**RE: James Dwyer Substation Parking Lot Expansion
12700 Montgomery NE
Grading and Drainage Plan
Engineer's Stamp Date: 2/27/19
Hydrology File: G23D011**

Based on the submittal received on 2/27/19, the Grading Plan and Drainage Report are approved for Grading and Paving Permit.

**Re: James Dwyer Substation Parking Lot Expansion
12700 Montgomery NE
Grading and Drainage Plan
Hydrology File: G23D011**

Attached is the grading and drainage resubmittal for Grading & Paving Permit Approval. The following items has been revised & provided per your comment letter dated February 15, 2019.

CITY OF ALBUQUERQUE DEPARTMENT OF MUNICIPAL DEVELOPMENT ON-CALL ENGINEERING SERVICES			
TITLE: JAMES DWYER SUBSTATION PARKING LOT EXPANSION DRAINAGE PLAN			
Design Review Committee	City Engineer Approval	Ms./Day/Yr.	Ms./Day/Yr.
City Project No. 6526.03		Zone Map No. G - 23 - Z	Sheet 6 Of

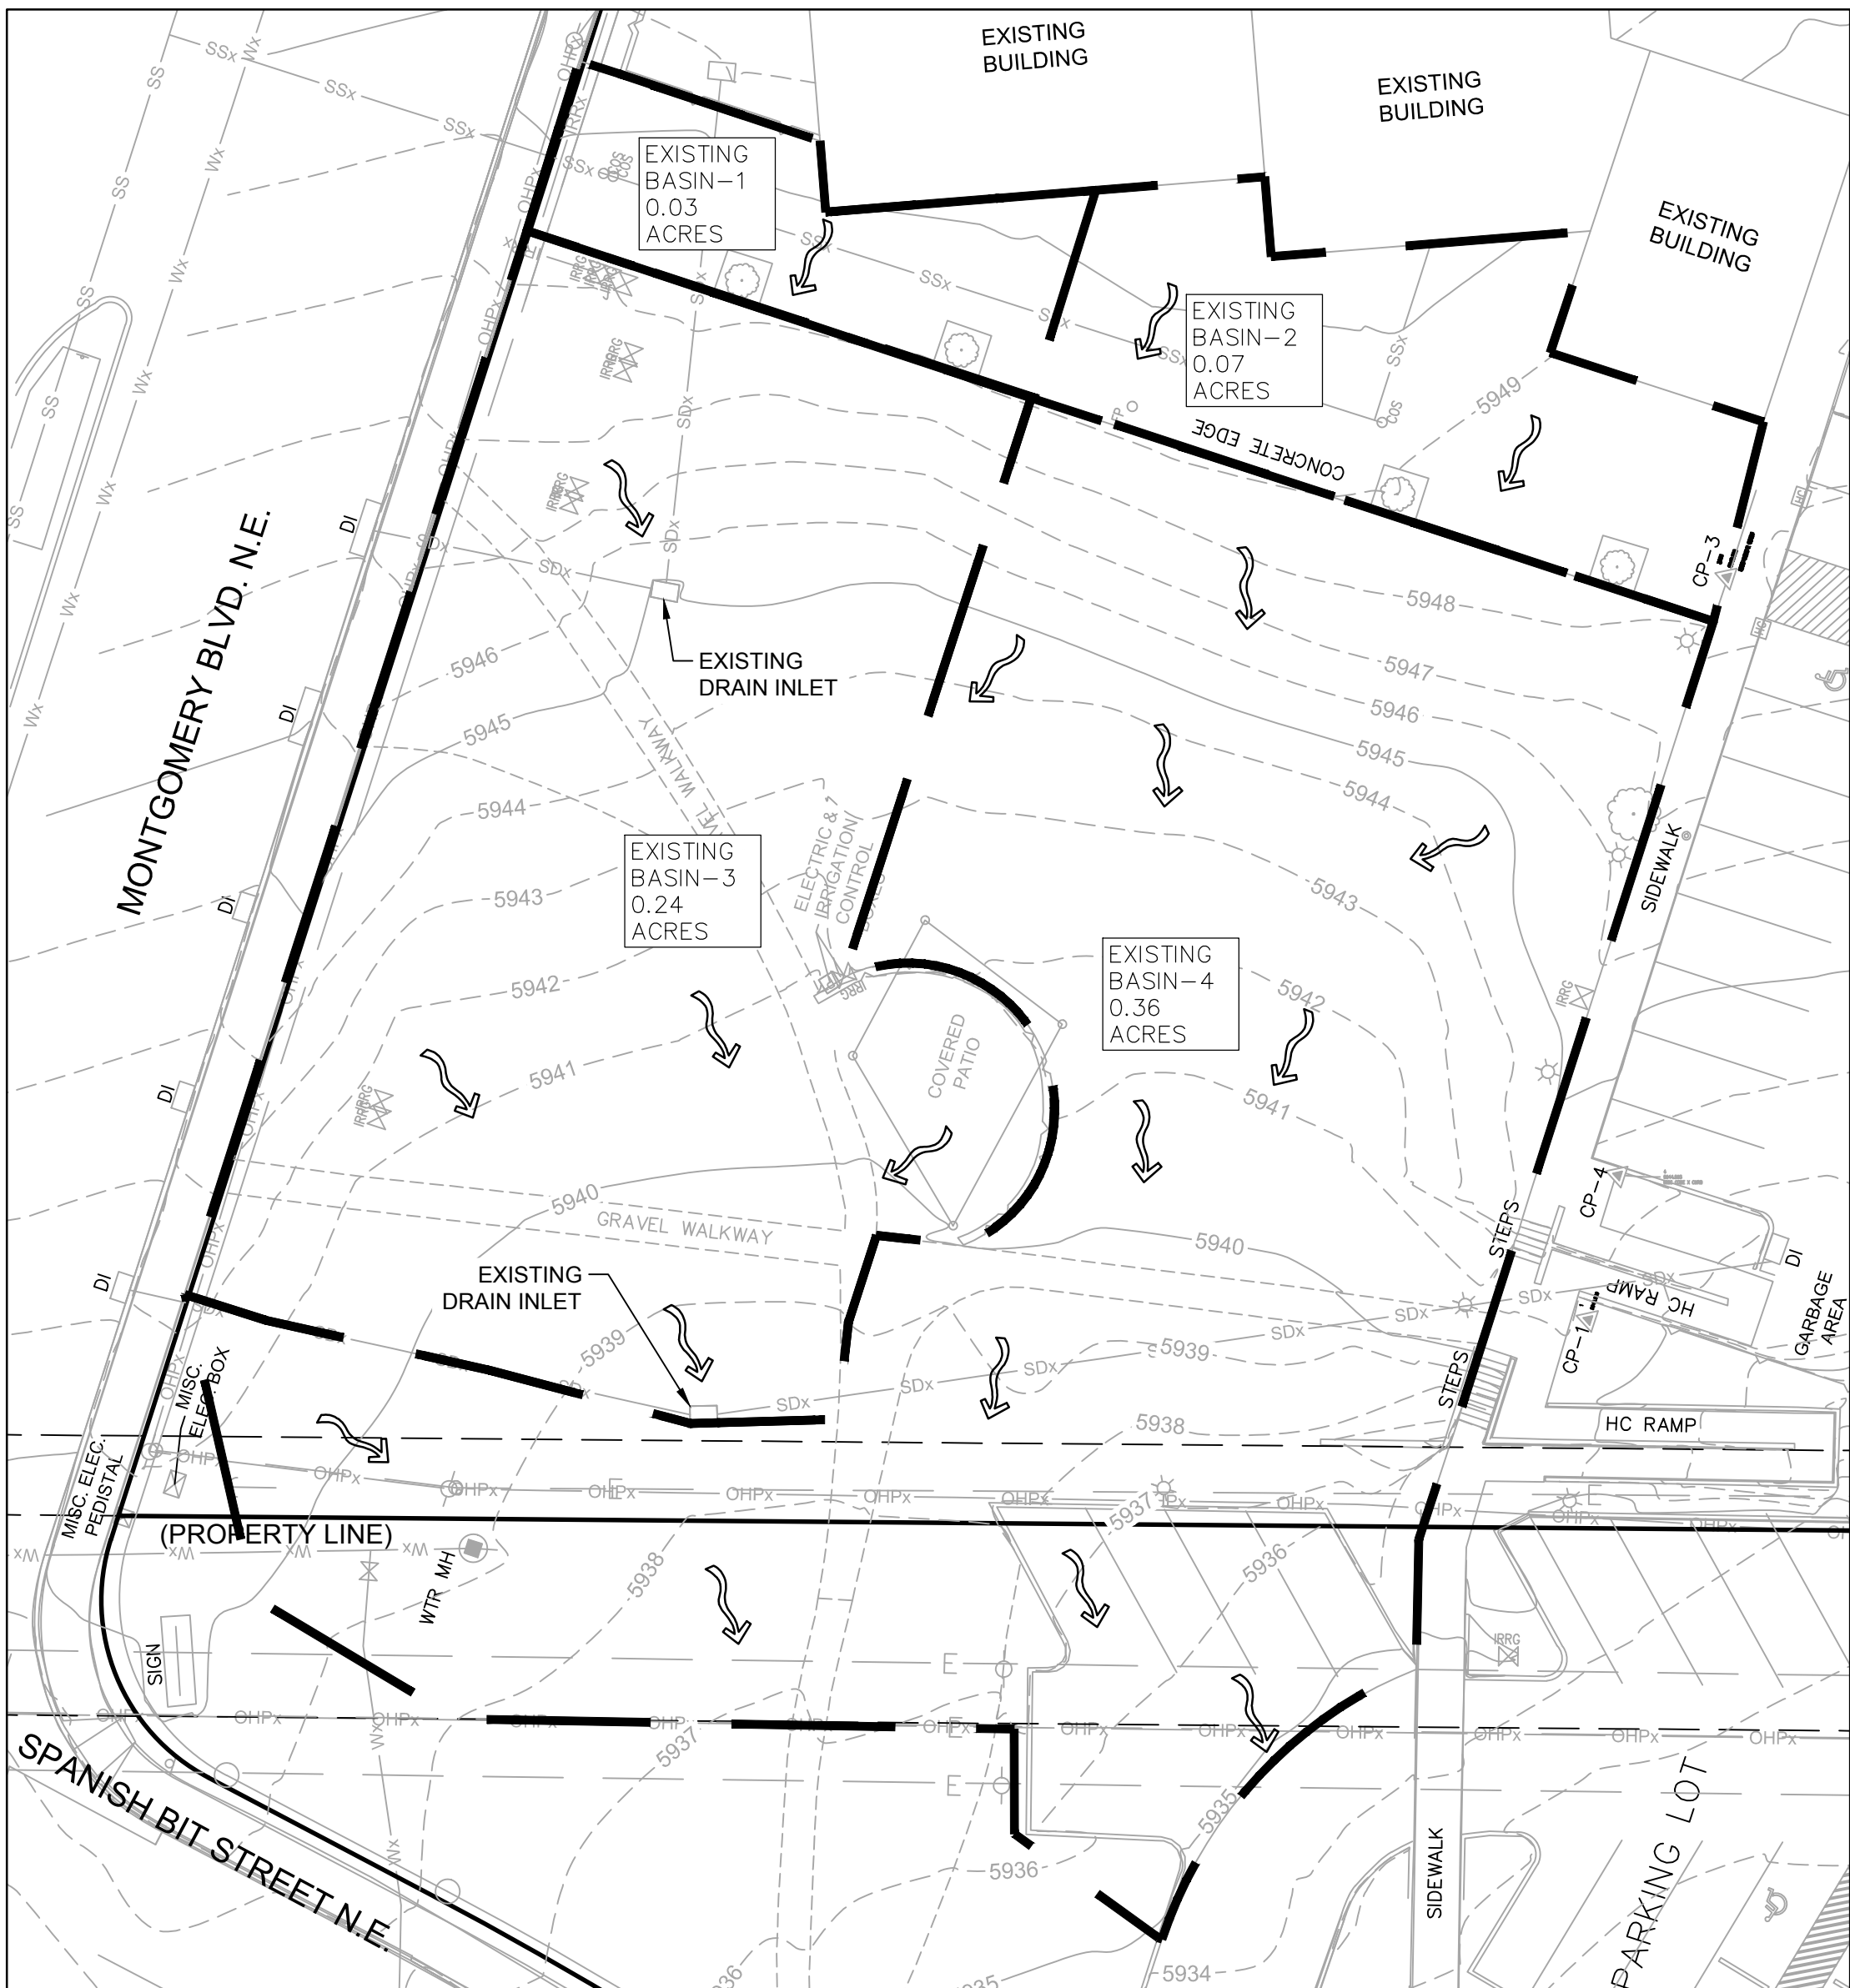
1. Revised Drainage & Grading Plan for undeveloped area
2. Provided drainage analysis support documents / calculation for detention pond
3. Revised Grading Plan between parking lot and back of sidewalk on Montgomery
4. Provide drainage analysis support documents / calculation for concrete run-down and valley gutter
5. Revised Grading Plan to add more spot elevations & included landscape planting plan to show erosion protection between corner of wall & adjacent stairs.
